ABS Sensor Replacement

MODELS AFFECTED: Blue Bird Visions with Hydraulic Disc Brakes

SO4HN

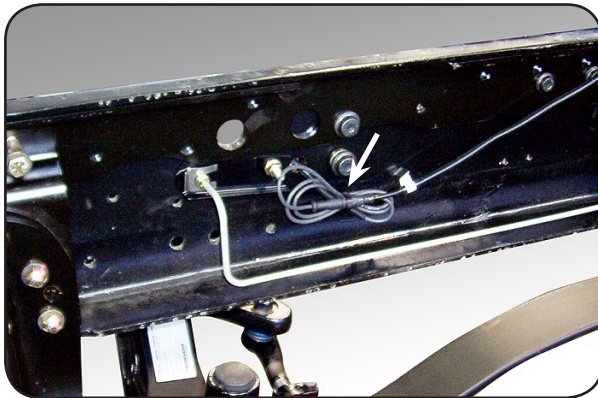
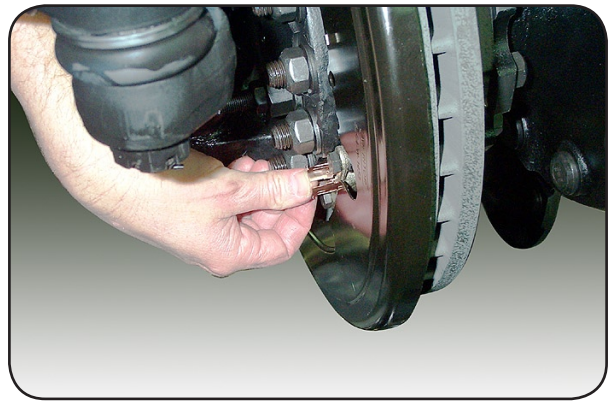
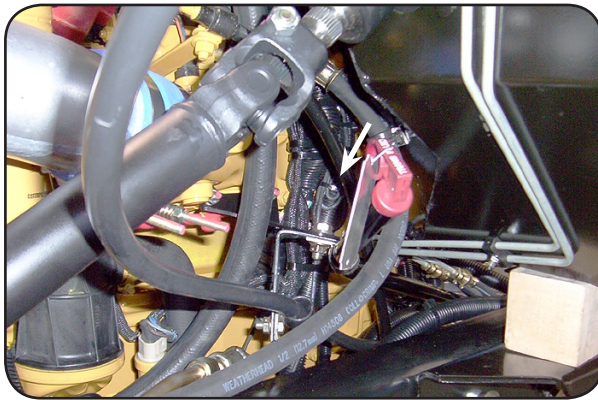
On some units with hydraulic brakes, the heat build up in the hydraulic front disc brakes may cause a false signal to be produced due to the sensors' inability to work within the designed operating range. The ABS light on the dash is turned "ON" and audible alarms sounds.

Replace the Bendix ABS sensor with a WABCO ABS sensor.

- 1** Park the bus on a level surface, apply the parking brake, remove the ignition key, and chock the wheels. Raise and secure engine hood.
- 2** On the inside of the right hand frame, locate the ABS sensor wire, cut the button head cable tie and disconnect the right front sensor cable from the wiring harness. Cut the remaining cable ties and remove the cable.

- 3** Pull the sensor straight out of its socket, using a twisting motion if required. Do not pull on the wires. If removal of the sensor is restricted by interference with the steering arm casting,, remove the two bolts which secure the sensor's mounting block. After removal, discard the Bendix sensor.

- 4** Pull the spring clip from the socket and discard.

- 5** Press the new sensor spring clip into socket until it stops.

- 6** If removal of the original sensor required removal of the mounting block, use a thread-locking compound on the mounting block bolts, remount the block, and tighten to 16–18 ft. lbs. (22–24 Nm). Lubricate the shank of the new sensor with the provided lubricant. Push the new sensor into the spring clip until it contacts the tone wheel.
